FINAL SITE GRADING CONSTRUCTION PLANS  
FOR  
**HILLSIDE AT LORSON RANCH FILING NO. 1**  
FINAL OVERLOT GRADING / EROSION CONTROL PLANS

COVER SHEET  
FINAL GRADING AND  
EROSION CONTROL PLAN

DATE: DEC 1, 2022  
PROJECT NO. 100.065  
SHEET NUMBER C0.1  
TOTAL SHEETS: 20

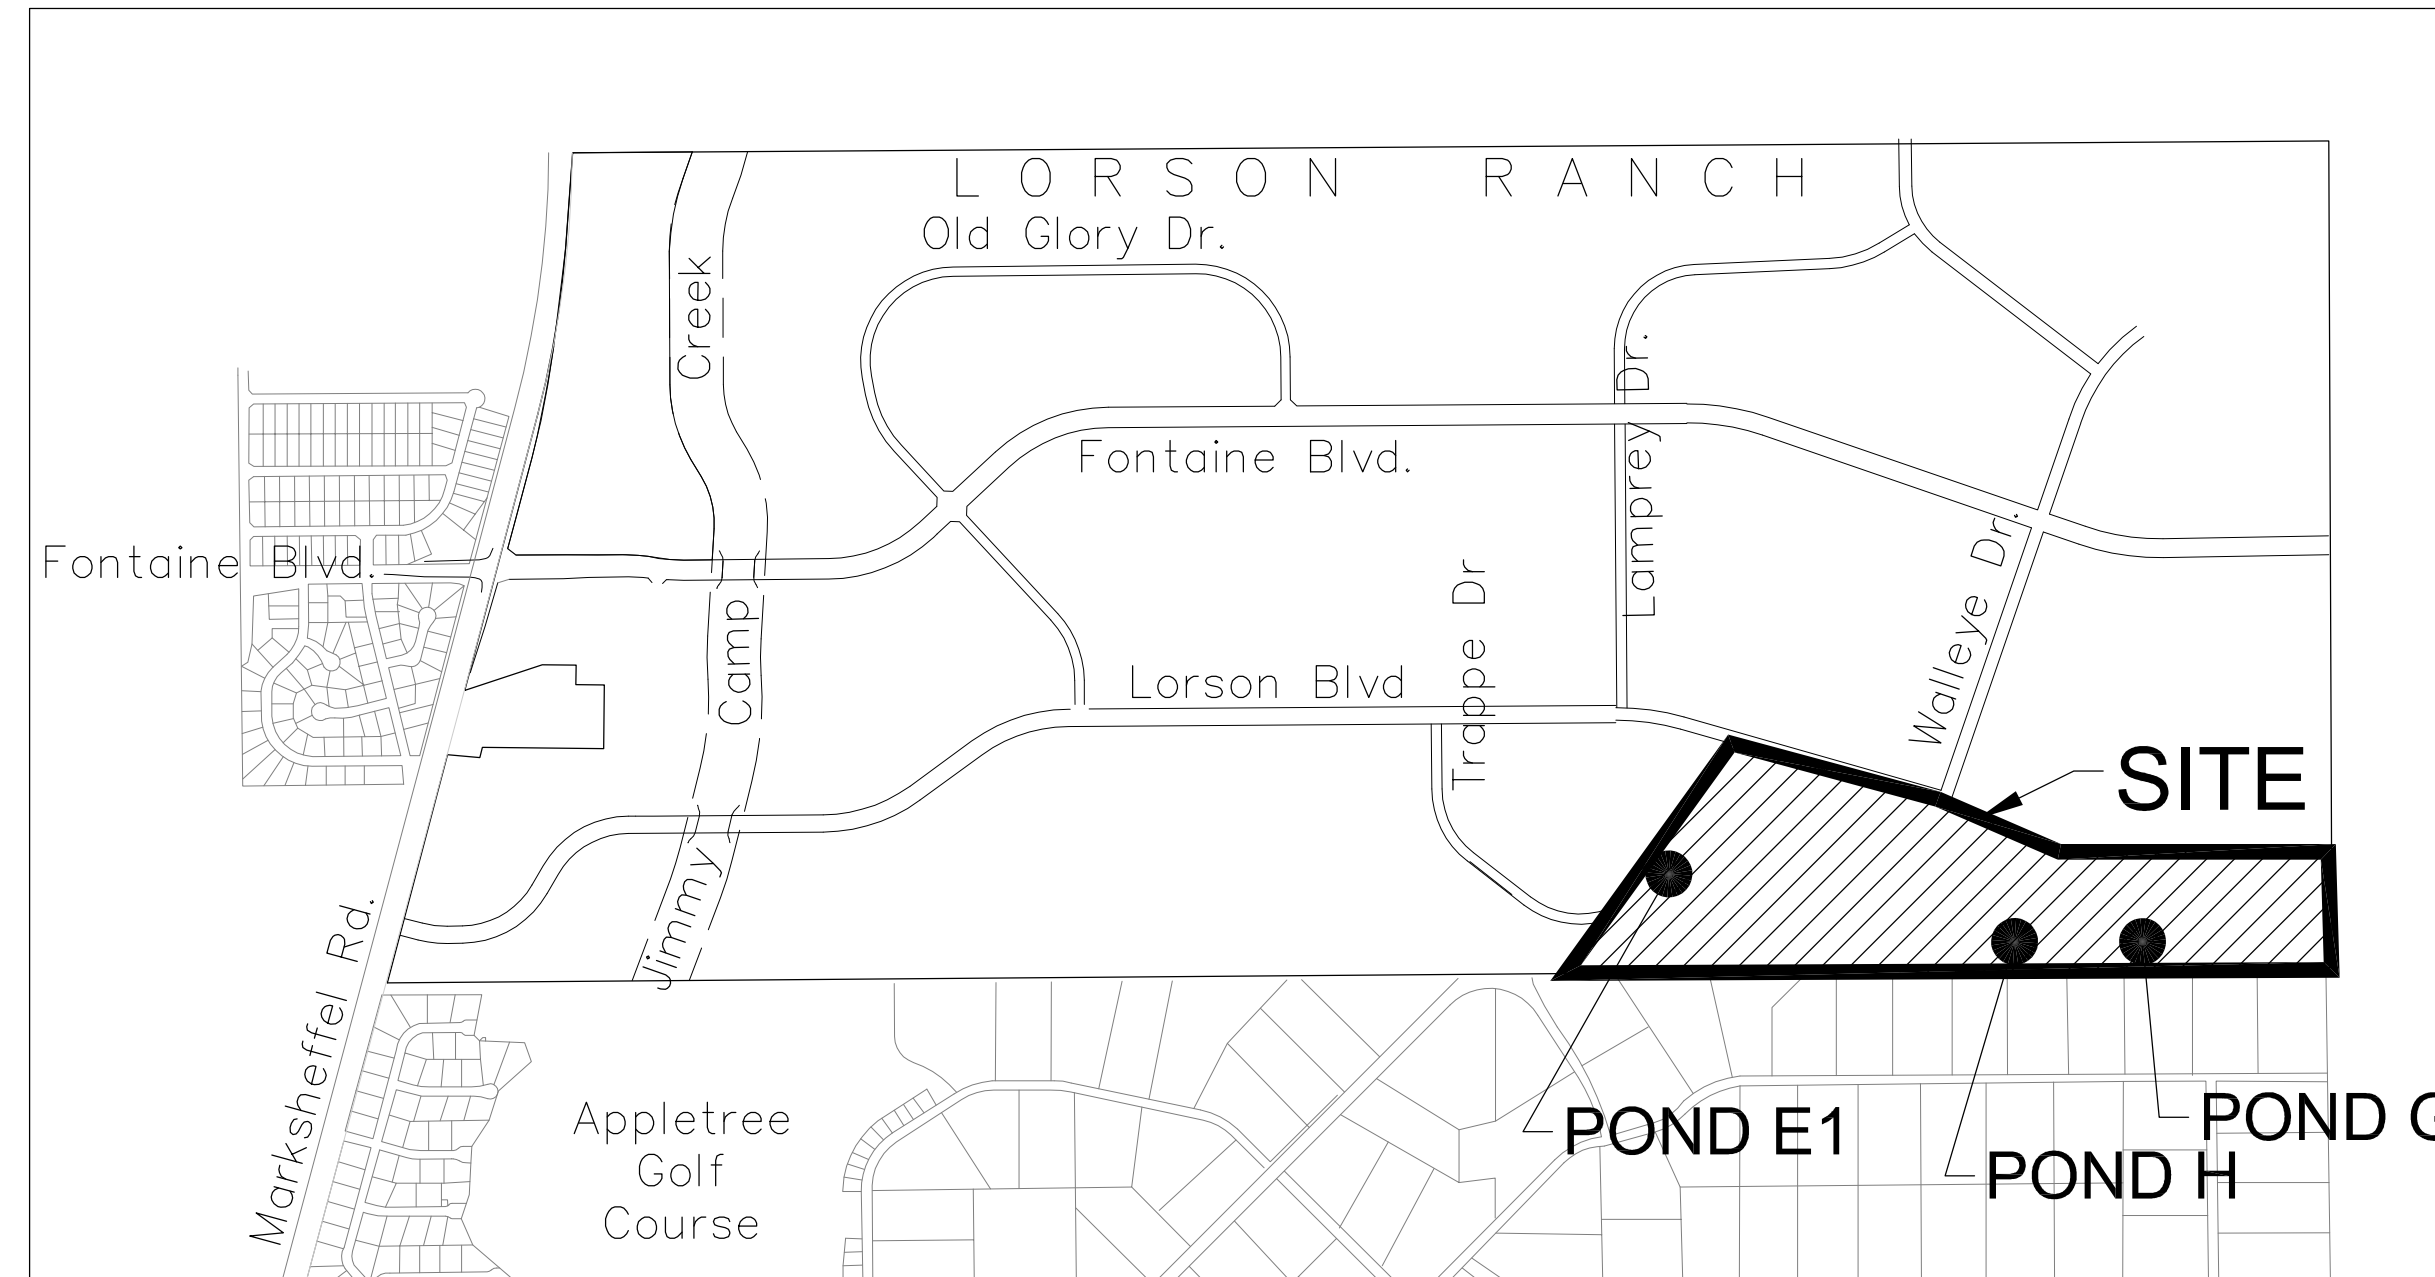
Revise to:  
"EPC's EDARP File Number: SF231"  
(with no dashes or extras zeros or extra spaces in the file number)

**HILLSIDE AT LORSON RANCH  
 OVERLOT FINAL GRADING AND  
 EROSION CONTROL PLAN**

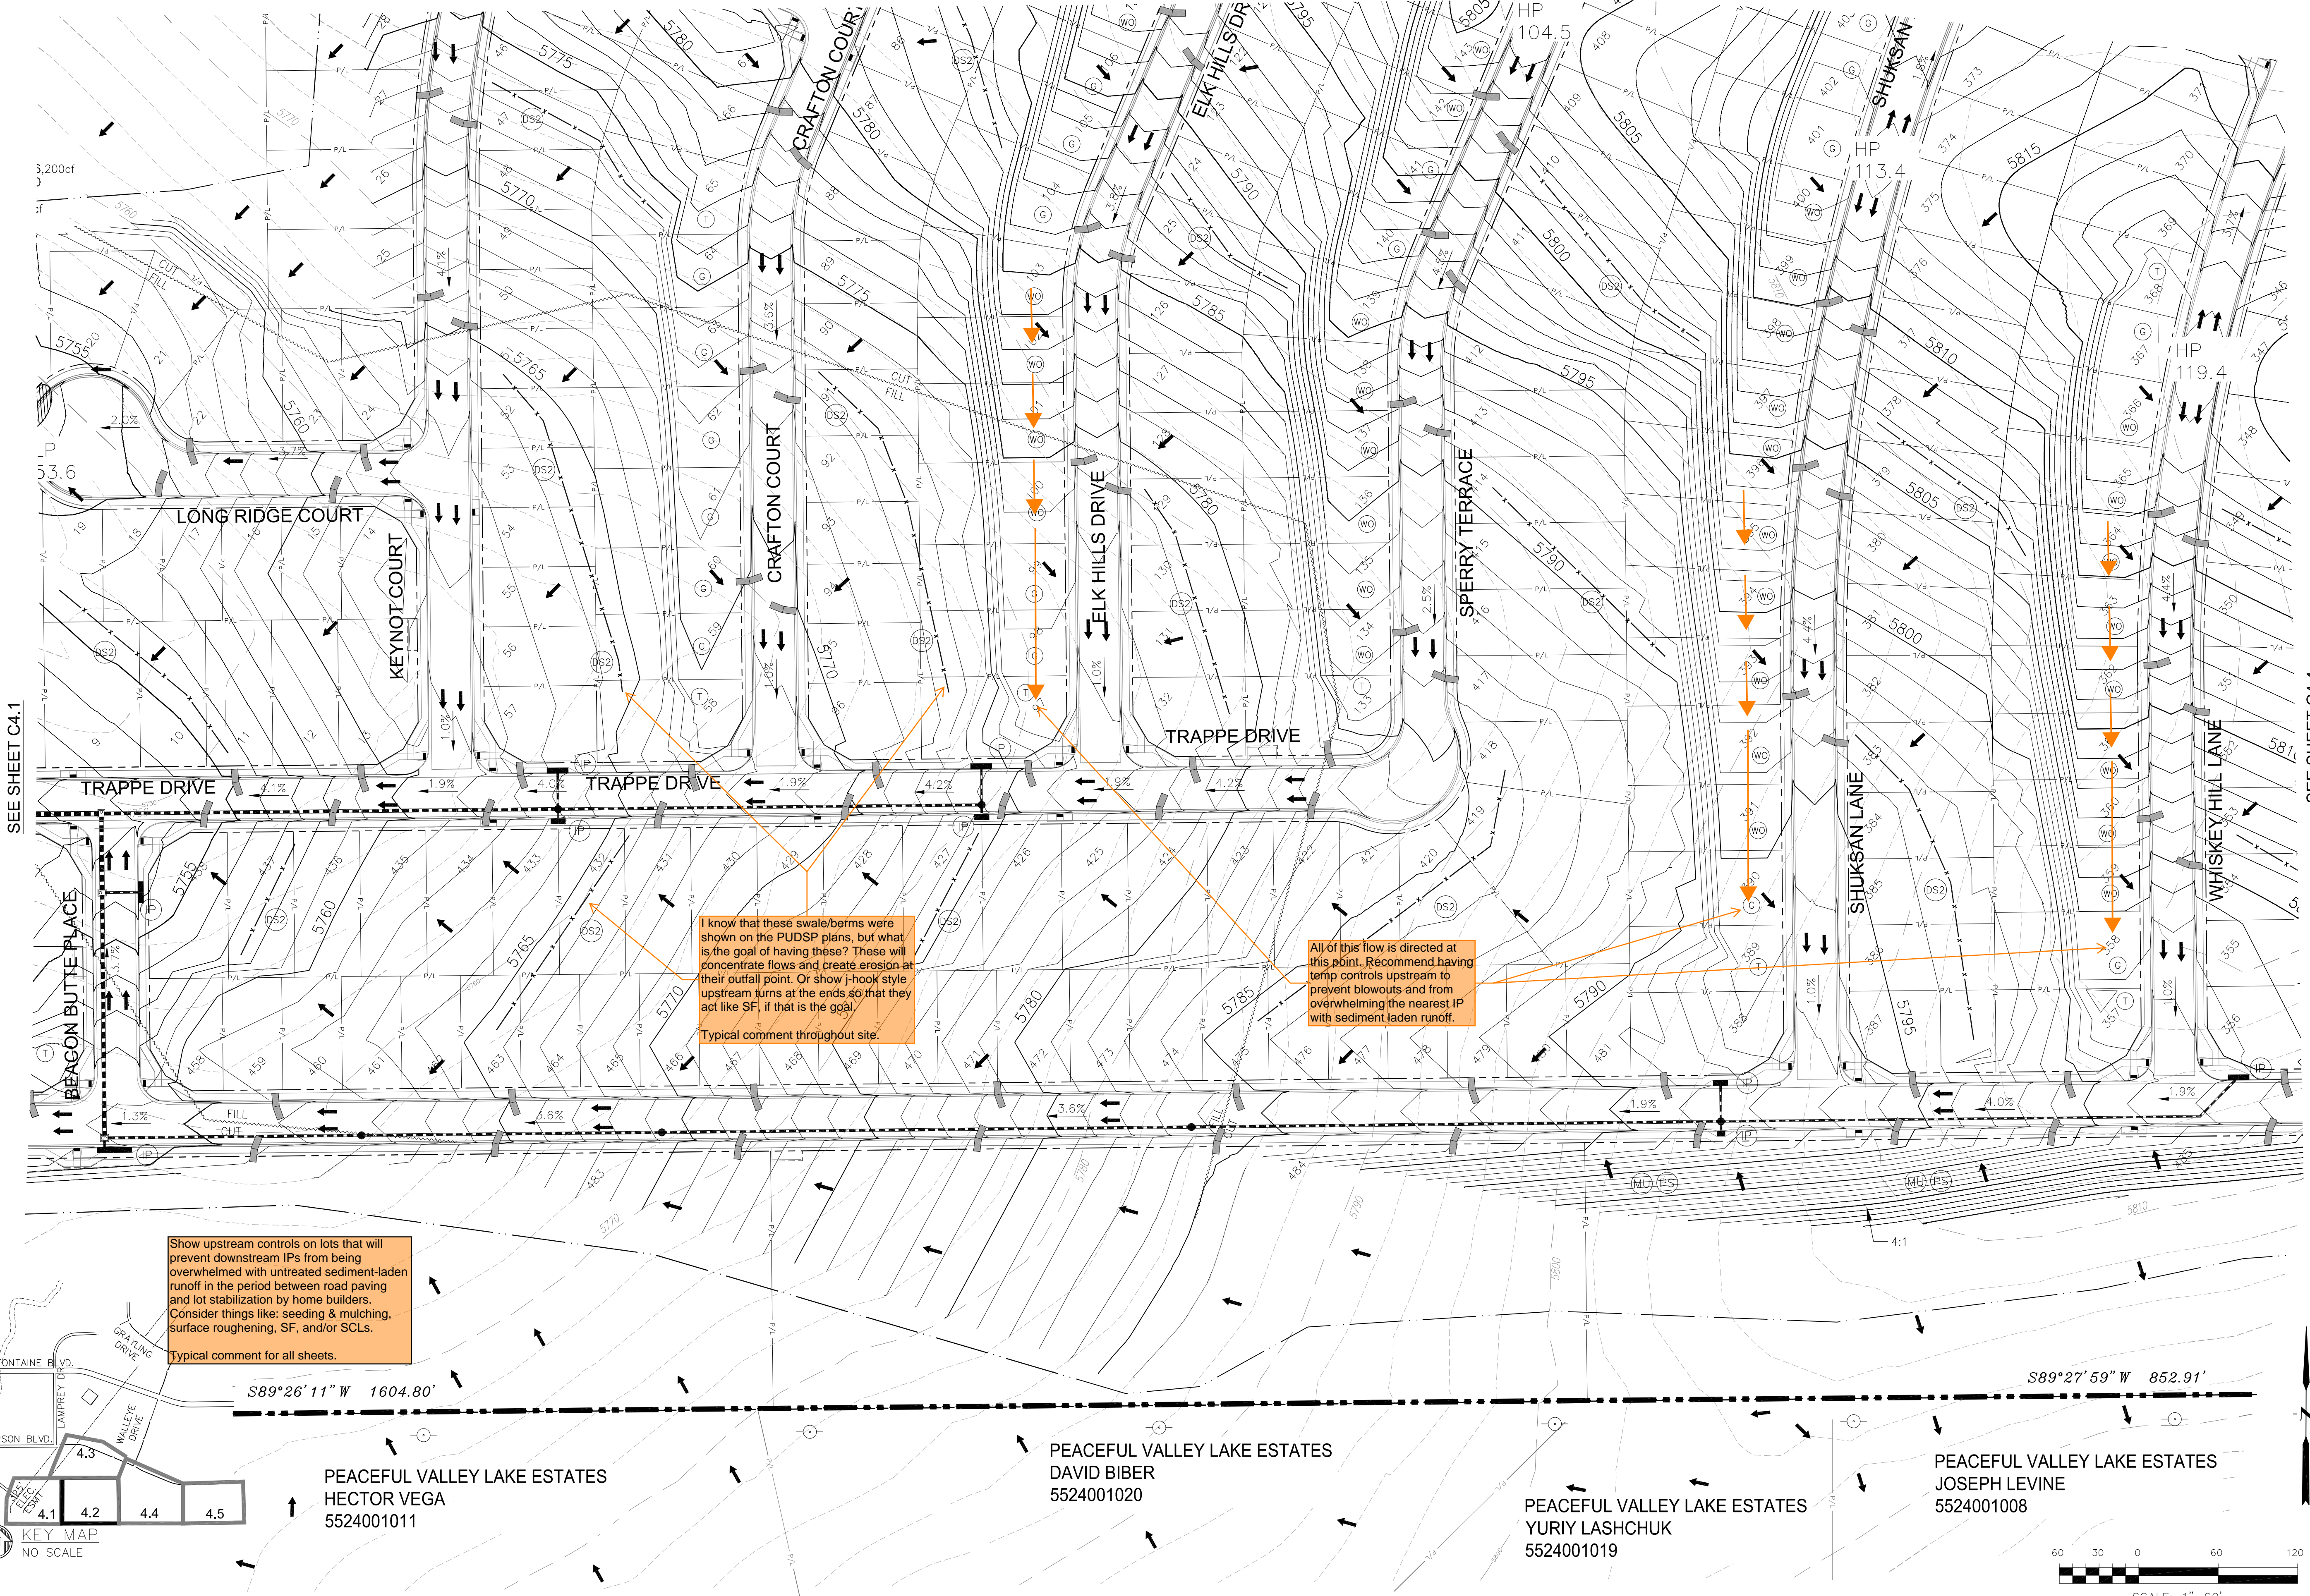
I know that these swale/berms were shown on the PUDSP plans, but what is the goal of having these? These will concentrate flows and create erosion at their outfall point. Or show j-hook style upstream turns at the ends so that they act like SF, if that is the goal.  
 Typical comment throughout site.

All of this flow is directed at this point. Recommend having temp controls upstream to prevent blowouts and from overwhelming the nearest IP with sediment laden runoff.

Show upstream controls on lots that will prevent downstream IPs from being overwhelmed with untreated sediment-laden runoff in the period between road paving and lot stabilization by home builders. Consider things like: seeding & mulching, surface roughening, SF, and/or SCLs.  
 Typical comment for all sheets.
